Access Compliance Report

Public Rights-of-Way

(Curb Ramps)

Intersection ID: 10019976	Main Street: ARENA_BV	Cross Street: N/A	Location: SE
ADA ID: 8B78A387739F	Ramp Type: PerpDiag	Initial Pass/Fail: Fail	Overall Compliance: No
Severity Score: 33.75			
Codes/Mitigation Info/Possible Solution		Field Measurements/Component Compliance

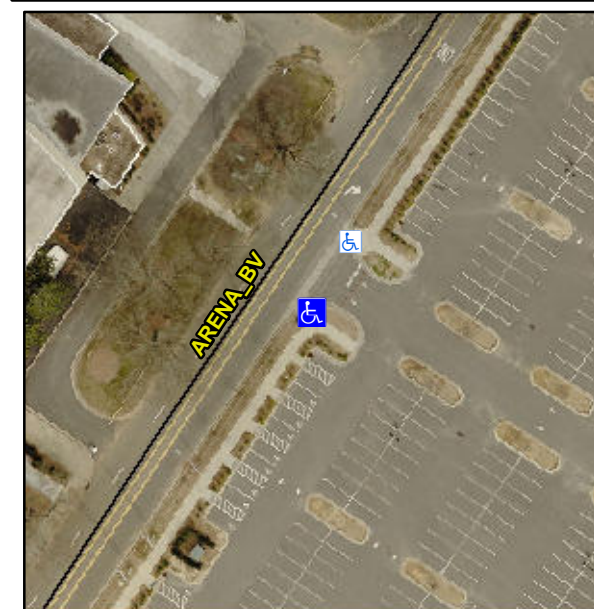
Not Found, R304.5.1, R304.2.2, R304.5.3

Compliance	Description	Data	Compliance	Description	Data
N/A	Ramp Length (in)	96.0	No	Ramp Slope (%)	8.7
No	Ramp Width (in)	46.0	No	Ramp XSlope (%)	6.0
N/A	Flare Type LT	N/A	N/A	Flare Type RT	N/A
N/A	Flare Slope LT (%)	N/A	N/A	Flare Slope RT (%)	N/A
N/A	Flare Traversable LT?	N/A	N/A	Flare Traversable RT?	N/A
N/A	Landing Length (in)	N/A	N/A	DWS Provided?	N/A
N/A	Landing Width (in)	N/A	N/A	DWS Contrast?	N/A
N/A	Landing Slope (%)	N/A	N/A	DWS Length (in)	N/A
N/A	Landing X Slope (%)	N/A	N/A	DWS Full Width?	N/A
N/A	Landing Curb? (Y/N)	N/A	N/A	DWS Offset (in)	N/A
N/A	Shared Landing?	N/A			
N/A	Gutter Ponding?	N/A	N/A	Gutter Slope (%)	N/A
N/A	Gutter Lip Ht (in)	N/A	N/A	Gutter X Slope (%)	N/A
N/A	Painted X Walk1?	No	N/A	Painted X Walk2?	No
	X Walk 1 Direction	To NE		X Walk 2 Direction	To NW
N/A	X Walk 1 Width (in)	N/A	N/A	X Walk 2 Width (in)	N/A
	X Walk 1 Slope (%)	1.3		X Walk 2 Slope (%)	6.8
	X Walk 1 X Slope (%)	5.8		X Walk 2 X Slope (%)	0.8

Remove & Replace Curb Ramp With Two New Directional Ramps or Equivalent.
